**Agenda Item # 7**

**Subject:** Zoning Text Amendment ZTA 20-0003 to repeal and replace the design control sections of the Los Altos Municipal Code to codify objective zoning standards pursuant to recent changes to state law.

**SUBJECT: ITEMS REFERRED BACK TO THE PLANNING COMMISSION-  
OBJECTIVE STANDARDS PROJECT**

**SUBJECT:** RESPONSE TO COMMENTS-OBJECTIVE STANDARDS PROJECT

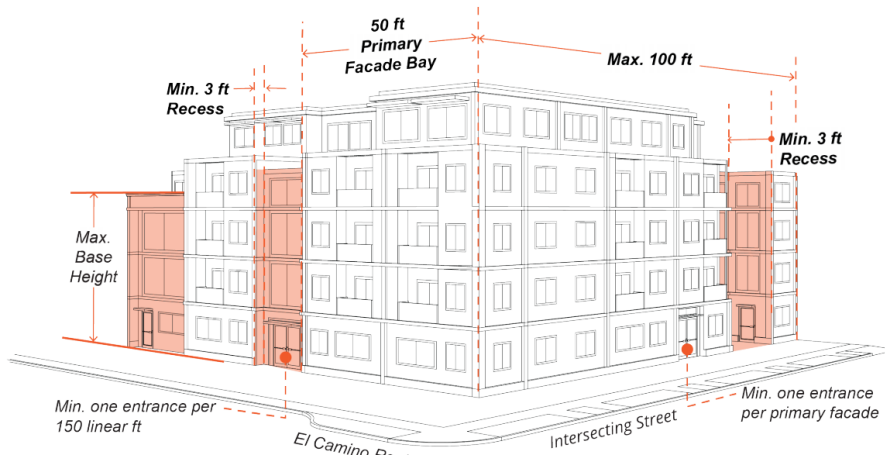
**6. Comment:** Does using upper floor heights as the reference by which first floor heights are determined allow for any undesirable consequences?

**The PC should review to ensure no unintended consequences in relationship to density bonus law.**

**Staff Response:** I think the commentor is asking the following question:

**CN zone:**

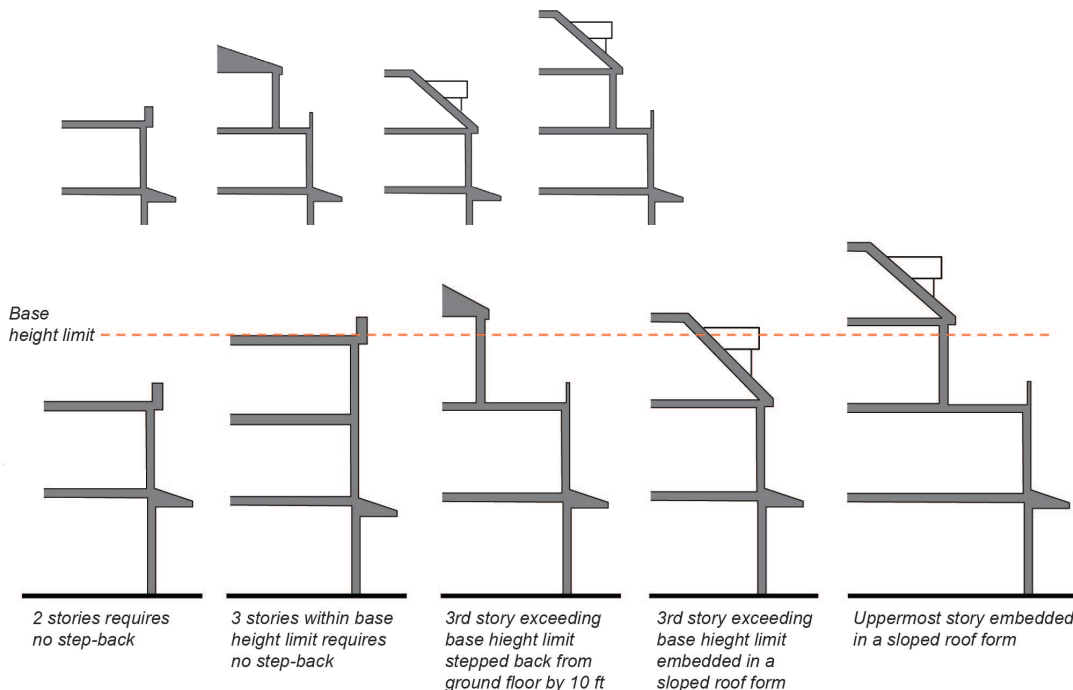
- a. The objective height limits for CN, CD, CRS, CD/R3 (commercial/mixed-use) and CRS/OAD are all 30' (35' for all residential in CD/R3). What is the rationale for having the set-backs and roof form requirements referenced to that 30' for CD and CD/R3 but to "stories" for the others? If the assumption is that the third story will always intercept the height limit, why not use the height limit numerically and provide a reference line on all diagrams? Or simply require everything above 2 stories to be set back according to the requirements.

Additional study for the PC and to make this distinction between stories and heights and treating the commercial zones differently in light of Density Bonus considerations

**Staff Response:** This is the same question as item #3 above. A little more background on this:

In the CD and CD/R3, however, there was less consistency in existing conditions. In these districts, the Commission and Council expressed a preference for setbacks required above the base height limit only (which is 30 or 35ft, based on use). As discussed in response to item #3 above, diagrams in previous drafts indicated this intent by showing the stepped-back portion dotted-in, above the base height limit.

In addition, the revised standard does still allow three stories with no required step-back, provided it does not exceed the base height limit.

**Revised 14.52.110 Design Control (CD/R3)**

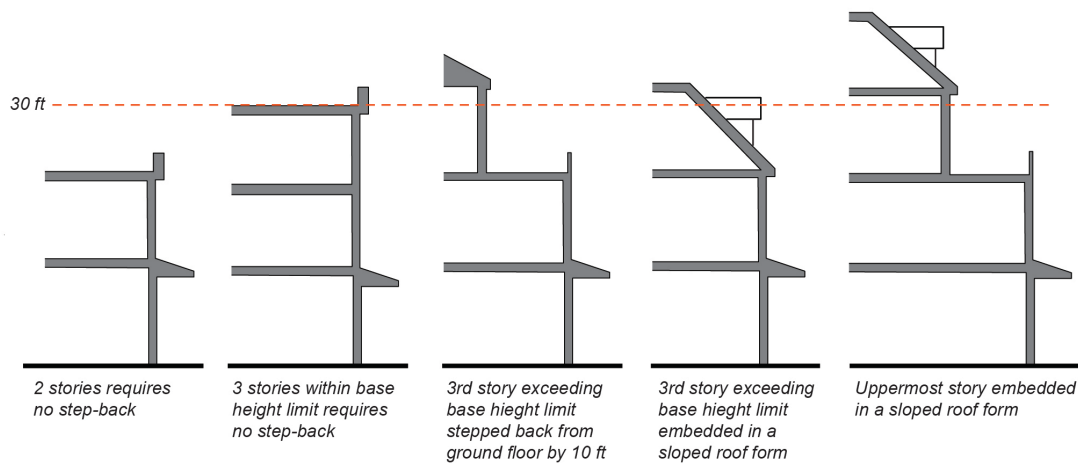
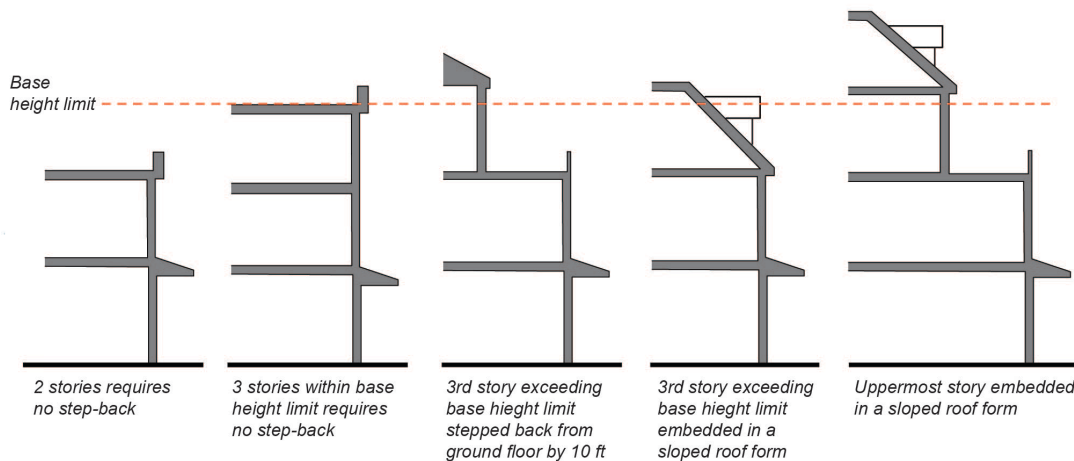
**Comment:** These sections had been changed from a building stepping back on the 5<sup>th</sup> Level or 4<sup>th</sup> Level to stepping back at 45'-0" or 35'-0". I'm not sure who proposed this change but having the step back occur at an arbitrary height is not wise. There are 2 projects in particular (5150 El Camino and 4350 El Camino) where the top of the 4<sup>th</sup> Level actually occurred lower than 45'-0". So essentially, we would be telling Developers to go up to 45'-0" and then step back, when, they might have gone lower to begin with. My other concern is the fact that a CT Development may incorporate Ground Floor Commercial at some point and the height from ground level to the 4<sup>th</sup> Floor would be very different than a purely residential building so we cannot just incorporate a random height number to trigger the stepback. I feel very strongly that this should go back to Levels and not a Height Number.

**Staff/Consultant Response: CD and CD/R3 districts:** As noted, this step-back was changed from being required at the 4th story to being required above the max base height (which is 30 or 35ft, depending on use). Diagrams in previous drafts indicated this intent by showing the stepped-back portion dotted-in above the base height limit. However, diagrams of previous drafts also showed 3 stories fitting within the base height limit, which is possible, but not typical. The revised standard addresses this fact and shows diagrams that more accurately reflect what will be built. In addition, the revised standard does still allow three stories with no required step-back, provided it does not exceed the base height limit

- a. *Front:* Minimum 10 feet from ground floor façade above 30 feet in height (commercial or mixed use) or 35 feet (residential only).
- b. *Street Side:* Minimum 10 feet from ground floor façade above 30 feet in height (commercial or mixed use) or 35 feet (residential only).
- c. For buildings over three stories, the uppermost story must be embedded in a sloped roof form such as a mansard roof or a hipped and/or gabled roof with dormers, as allowed by standards in Section A.6.

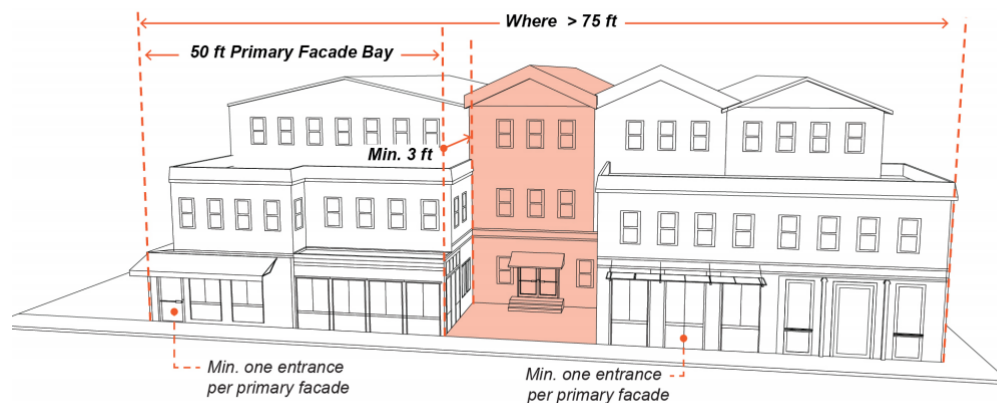
**9. Comment:** Does using upper floor heights as the reference by which first floor heights are determined allow for any undesirable consequences?

**The PC should review to ensure no unintended consequences in relationship to density bonus law.**

**Staff Response:** I think the commentor is asking the following question:

**CD zone:**

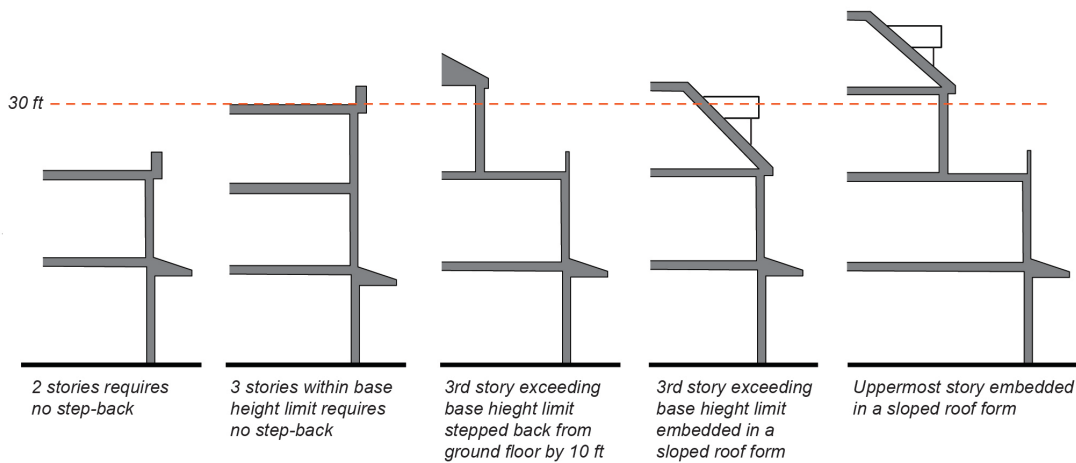
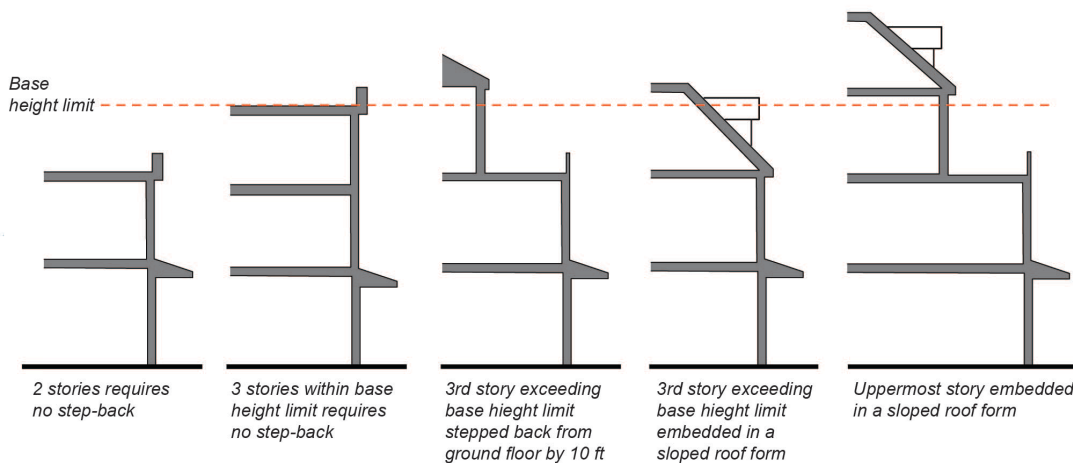
- b. If we stick with describing height in feet, then as CD/R3 is 30' for commercial or mixed use but 35' for all residential, it would be useful to add a dashed red line at 35' to the diagram

**Staff Response:** Text clarified to match diagrams.

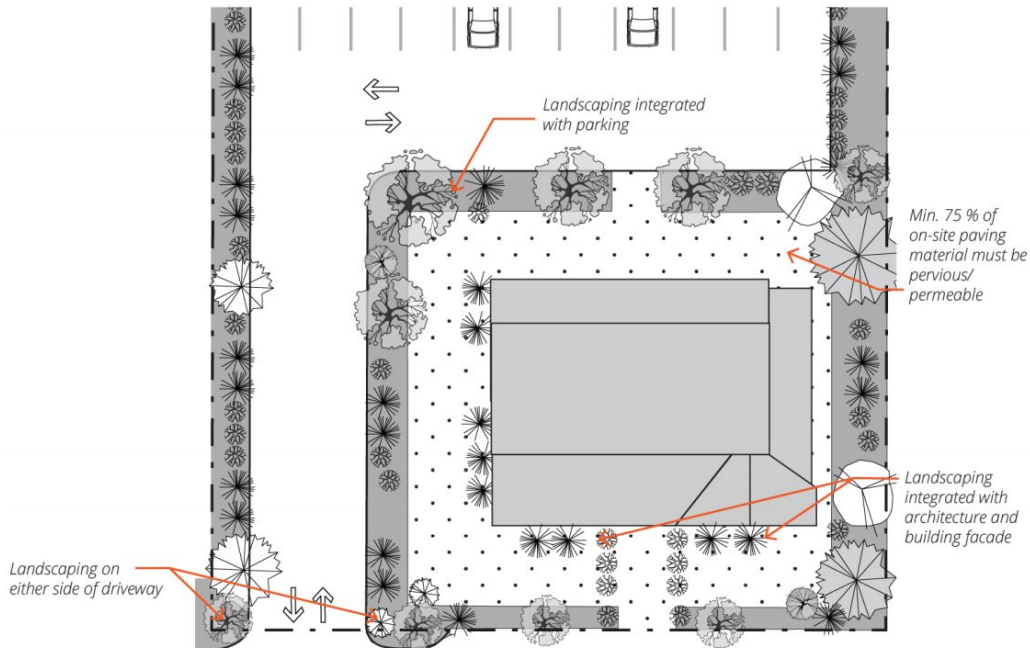
Comment 23b-F5- assume those separate sections cover fast growing, etc

5. See Sections 14.66.180 (Maintenance of Landscaped Areas) and 14.70.070 (Landscaped Strips) for additional landscaping standards.
